# TOWN OF ESSEX CERTIFICATE OF OCCUPANCY APPLICATION

NO. 116-97

Re: **CERTIFICATE OF OCCUPANCY #116-97 FOR BUILDING ADDITION TO THE  
EXISTING FURNITURE STORE**

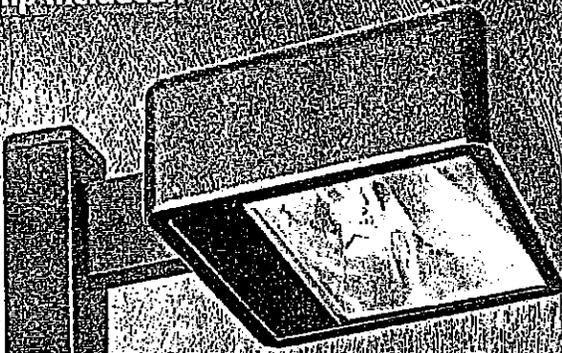
2. All proposed exterior lighting including sources located on or within buildings shall be installed and shielded in such a manner as to conceal light sources and reflector/refractor surfaces from view beyond the perimeter of the area to be illuminated.

These fixtures as shown on Attachment B are found to be in compliance with the Zoning Regulations if incandescent light sources of 100 watts or less are used. No fixtures mounted to the sides of any of the buildings are shown on the plan and none are approved.

The lights proposed to illuminate the sign must meet the requirements of Section 25.10.4 (c) of the Zoning Regulations.
